# PLANNING APPLICATION FOR THE EXPANSION OF A MATERIALS RECOVERY FACILITY AT CAPPOGUE AND DUNSINK, BALLYCOOLIN ROAD, DUBLIN 11.

## Response to Request for Further Information

**Abstract:** This report contains the response to a Request for Further Information (RFI) in connection with planning case number ABP-315257-22 for development at Cappogue and Dunsink, Dublin 11.

STORM CULVERT SKETCH - DETAIL 1

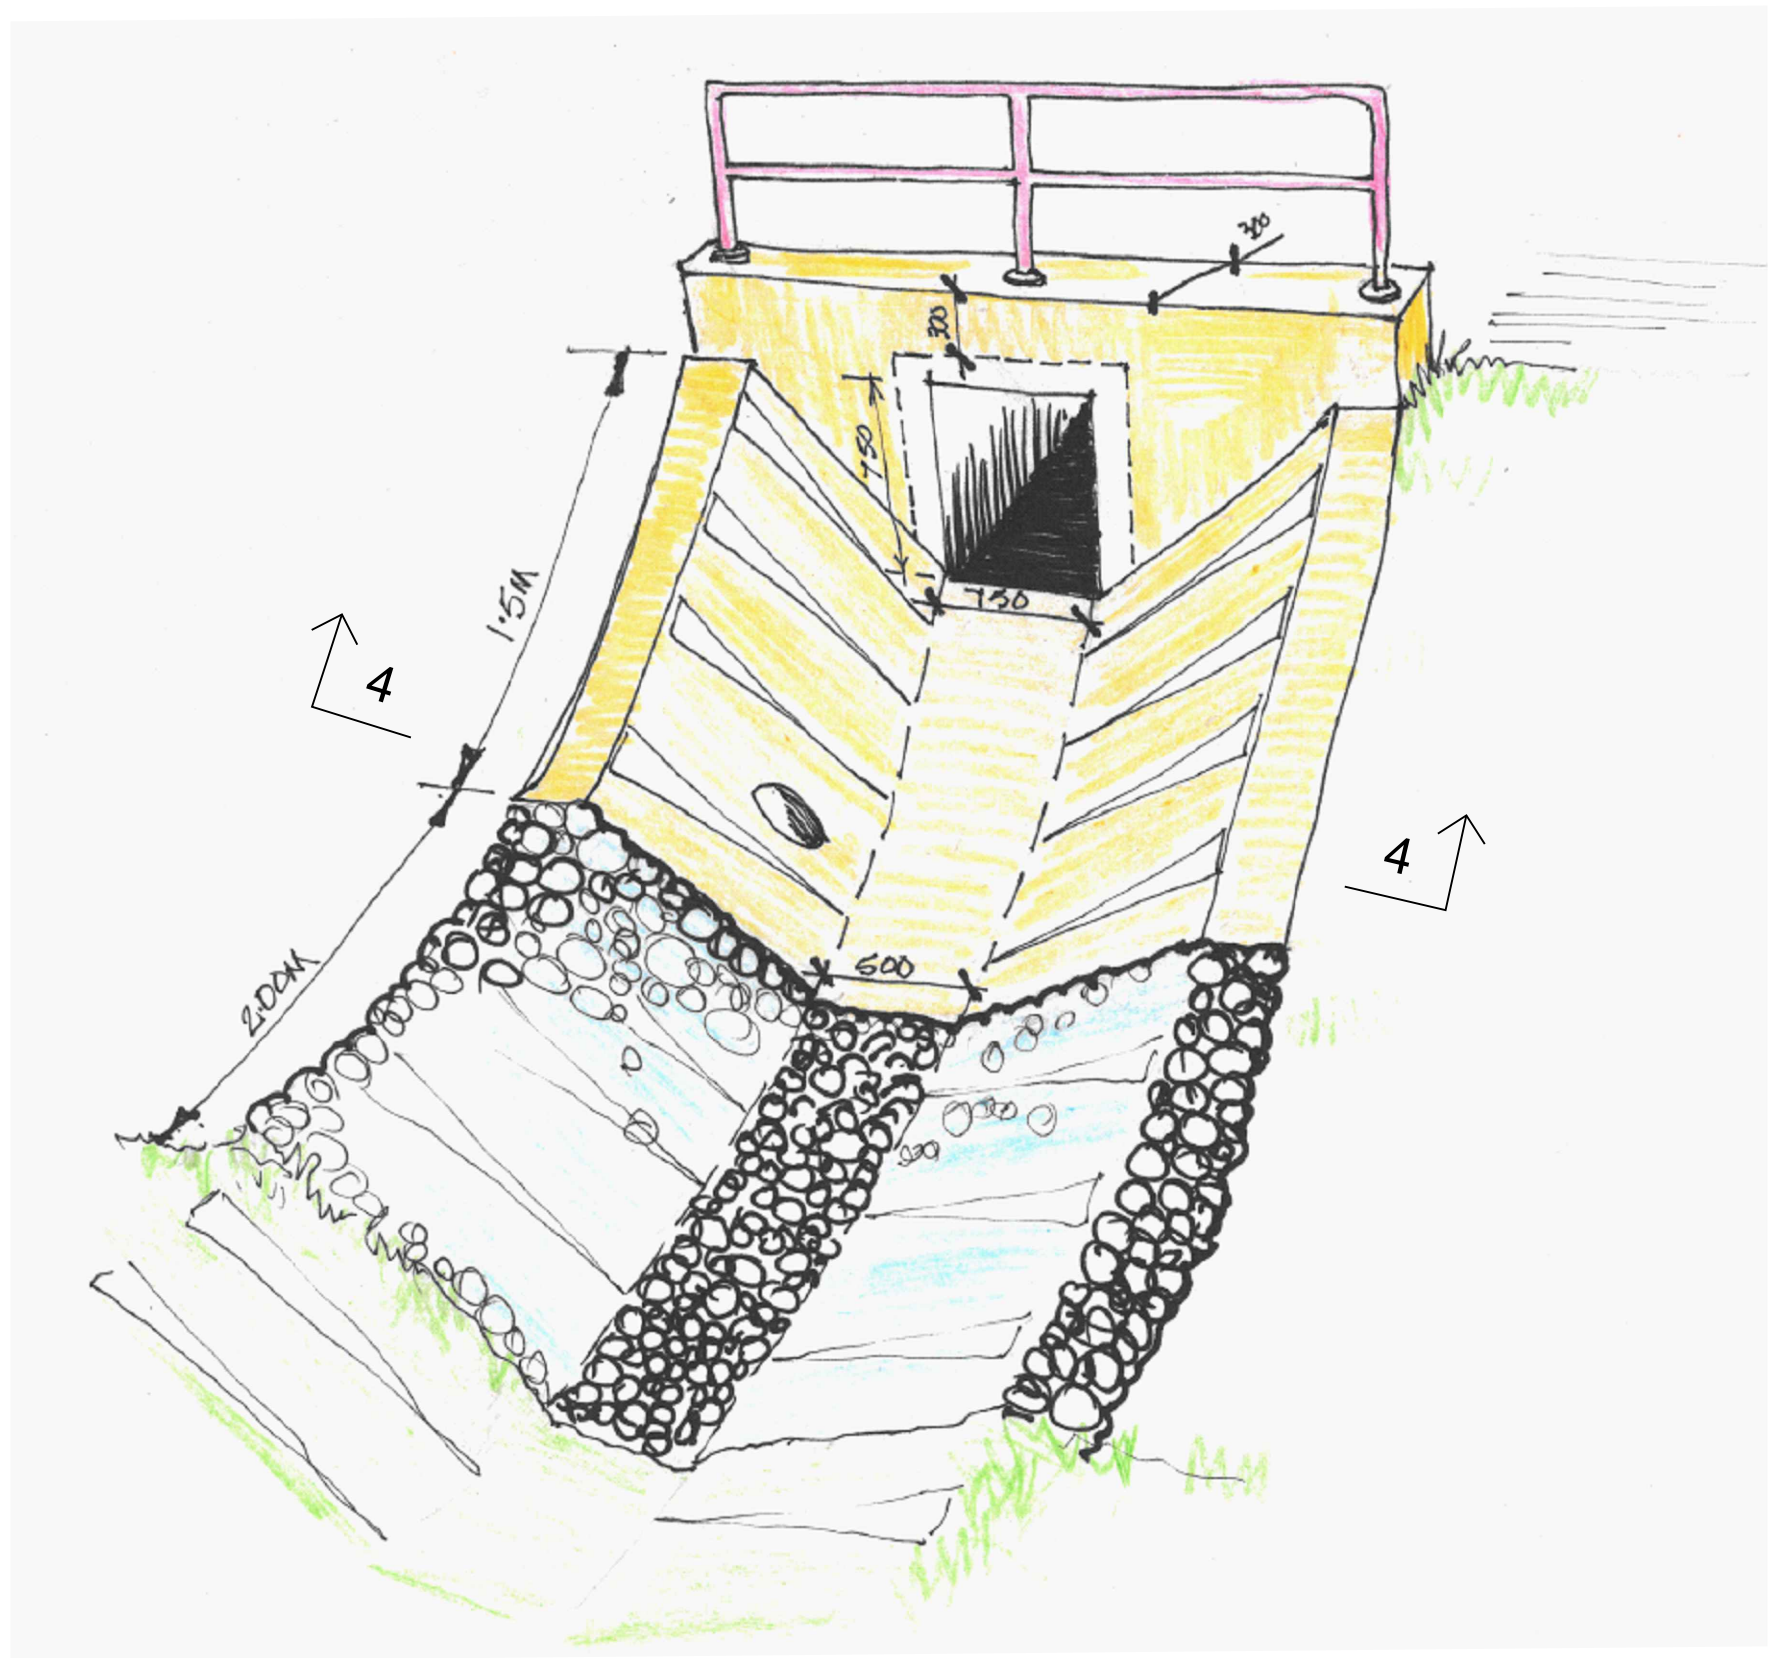
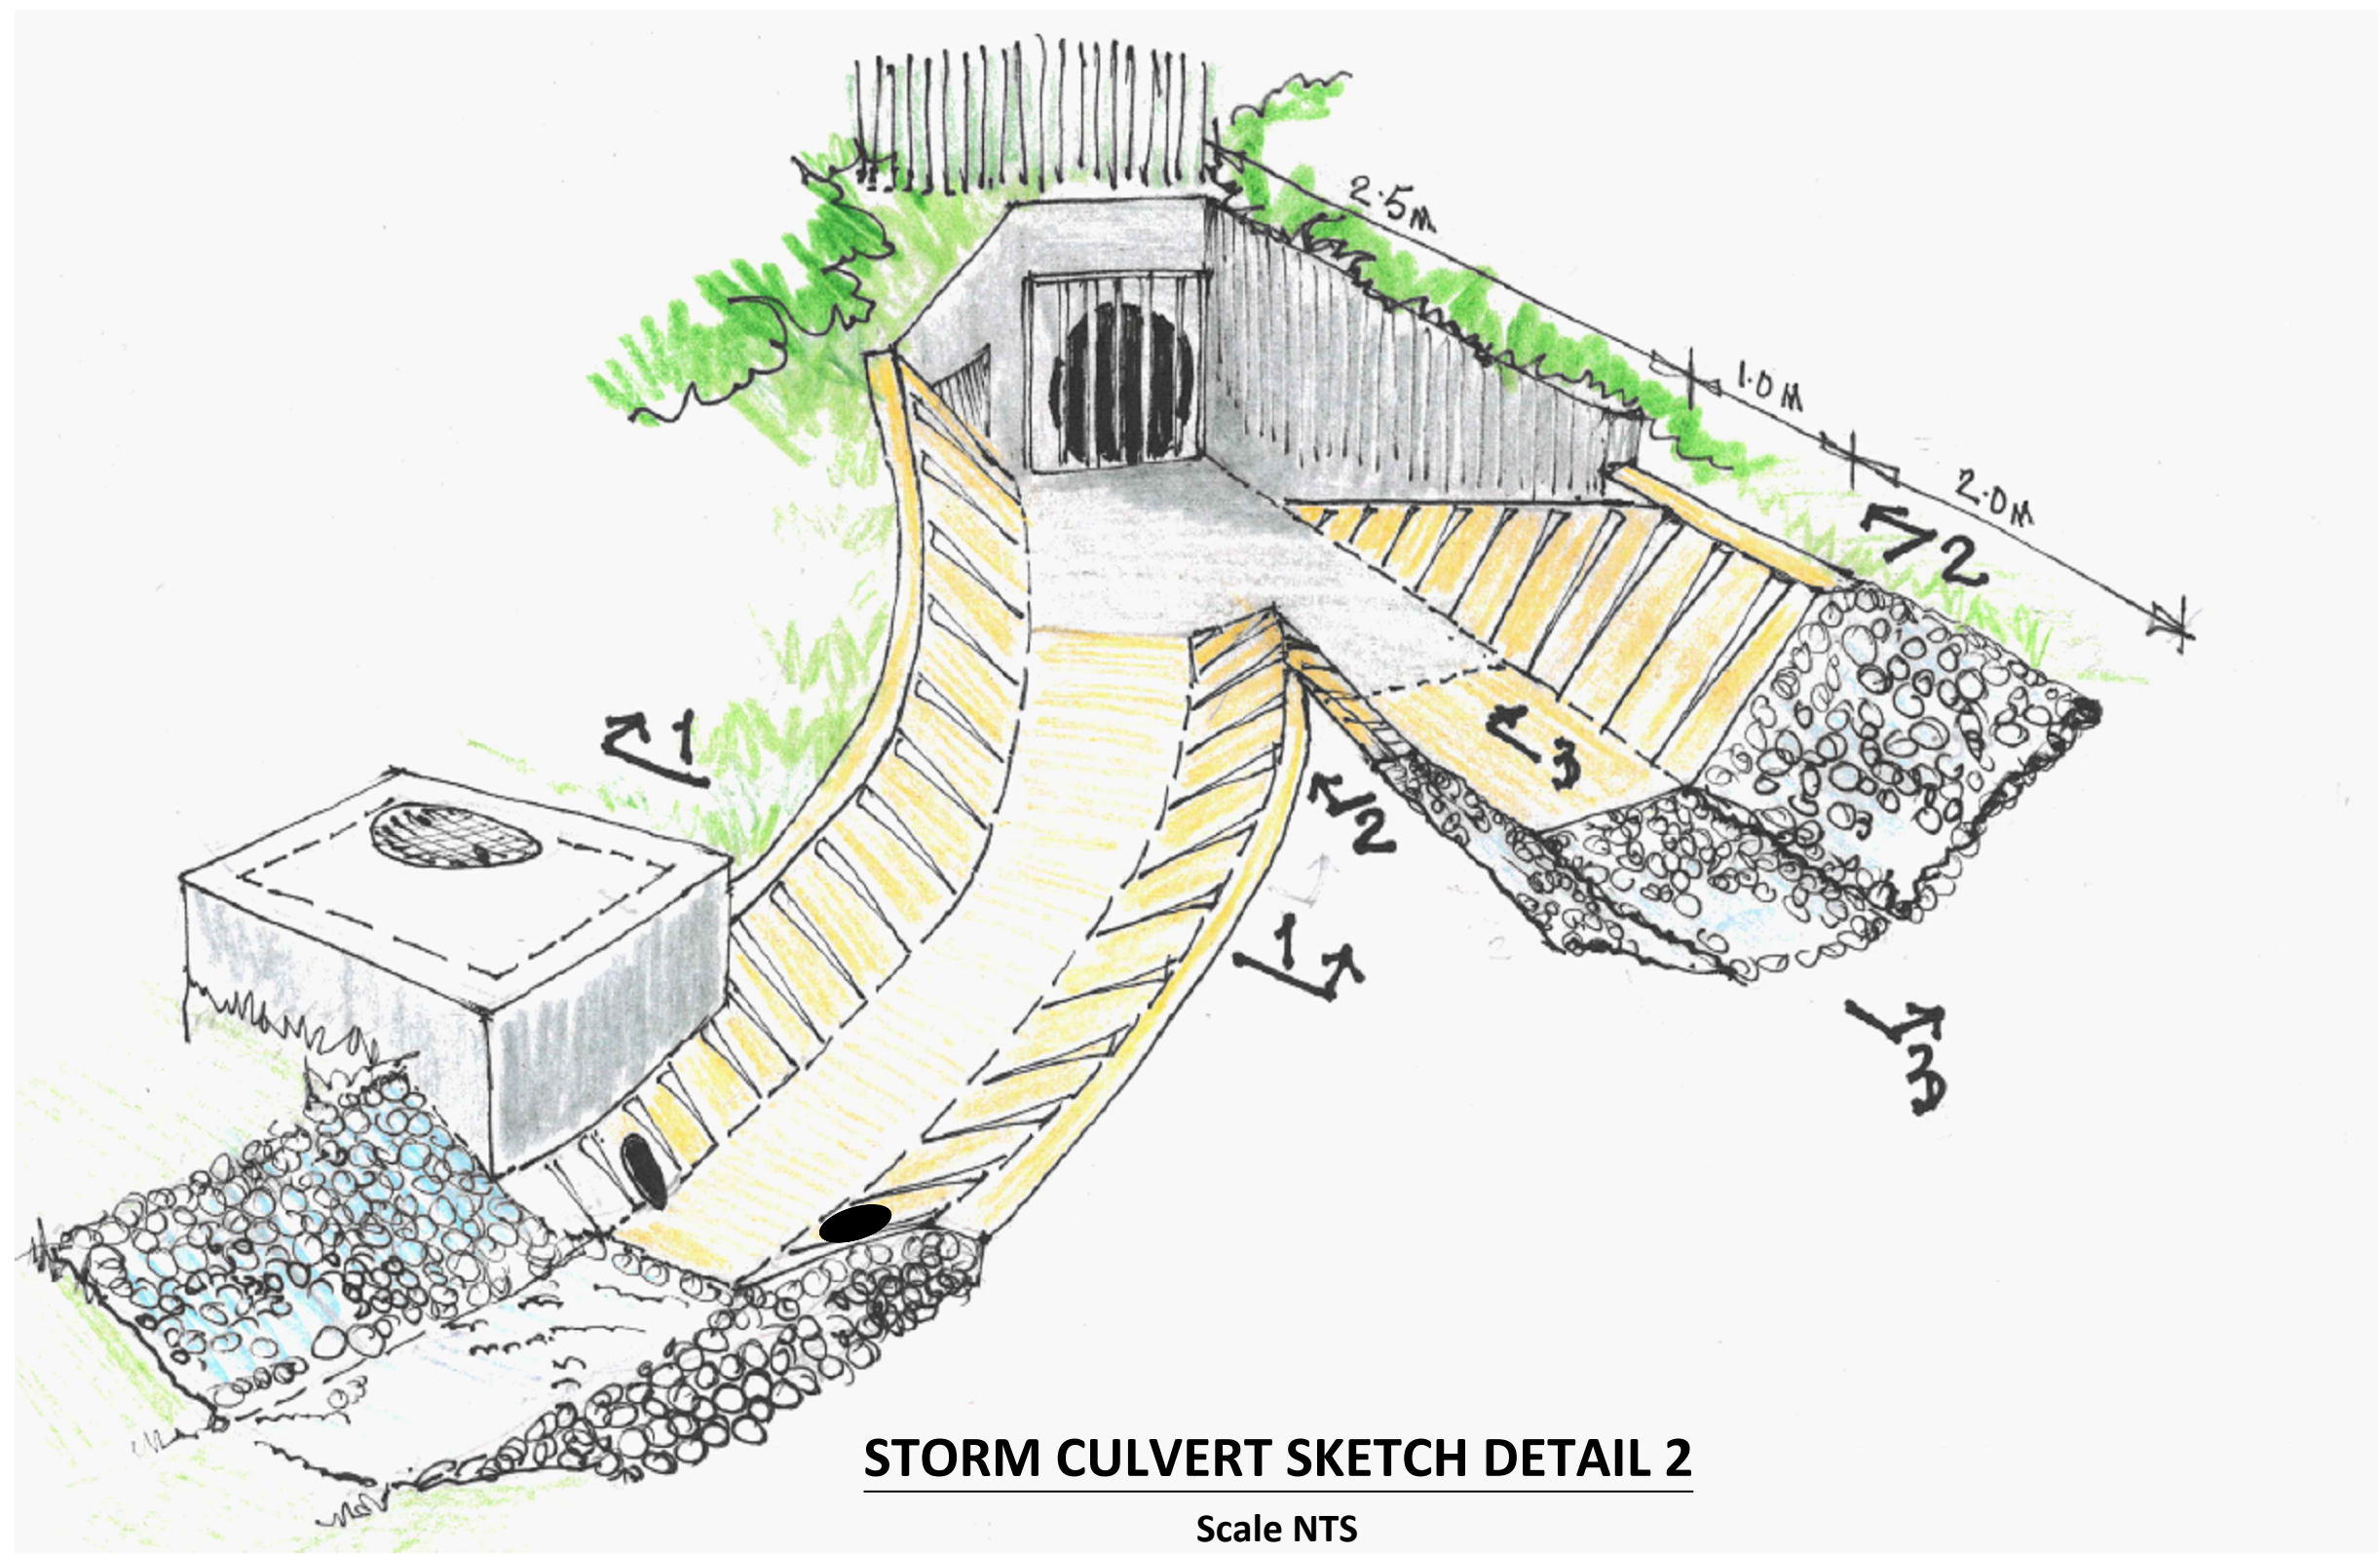
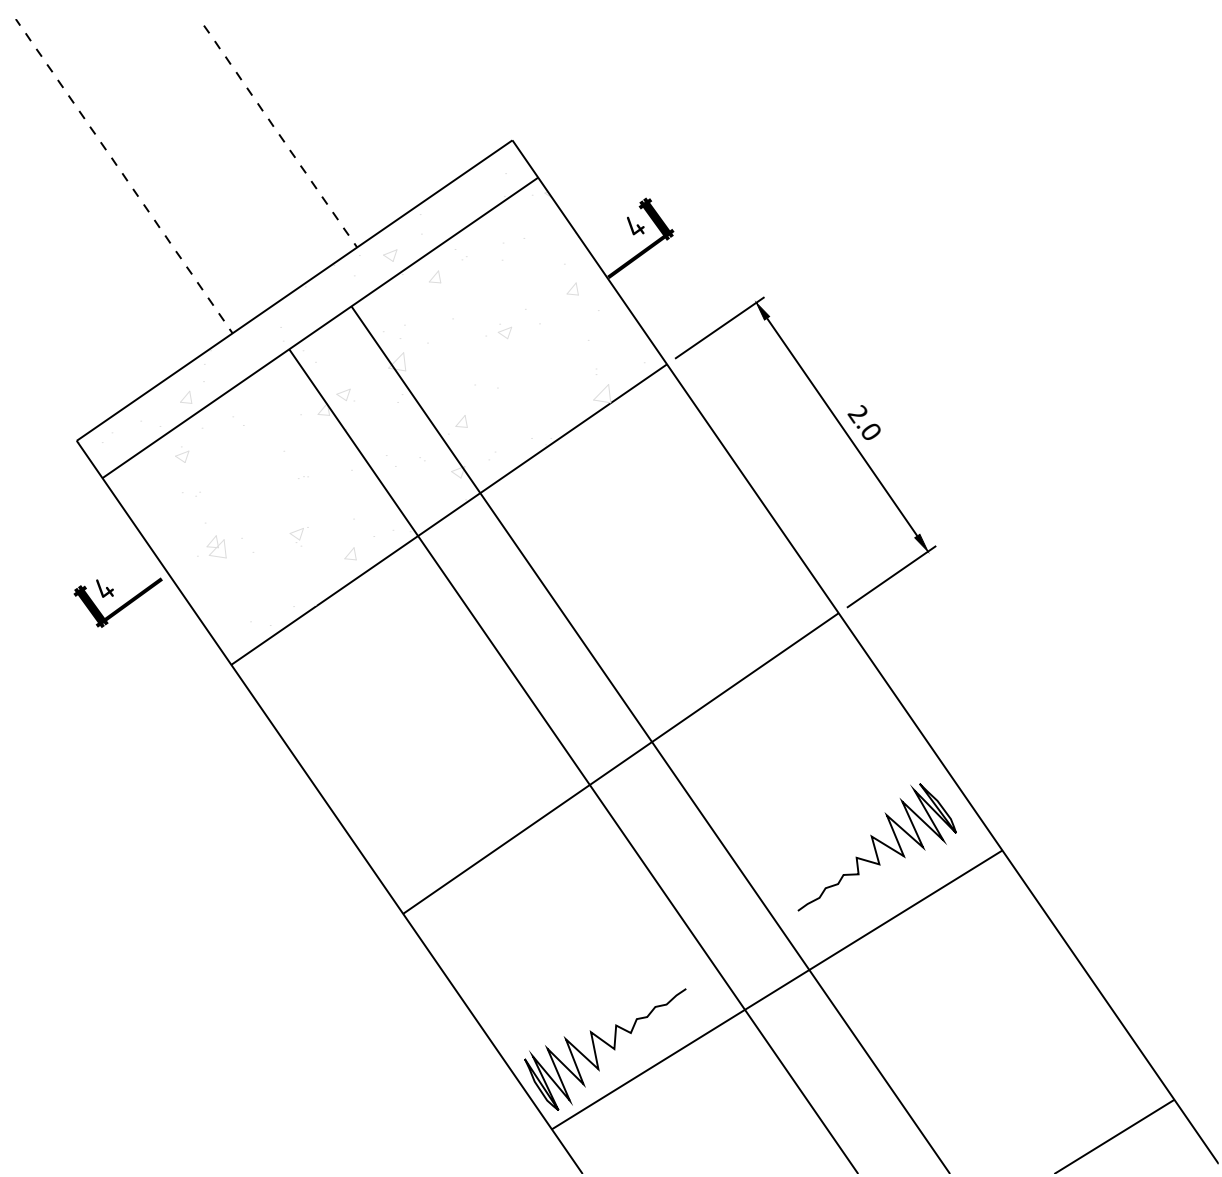
On 06/10/2023 TII Land Use Planning issued a letter response via email and is included in Appendix 3. TII requested clarification in regard to the structural condition of the M50 culvert, the potential impact of the concrete lining and the potential impact of any exceedance flow on the culvert.

- Protect the inlet works during construction.
- Facilitate future access as required to unblock the trash rack.
- Provide scour protection at the interfaces between lined and unlined channel sections. See Figure 2 and Drawing P21-150-0700-0011 RevB Proposed M50 Culvert Inlet Details details 1 and 2 in the enclosed.
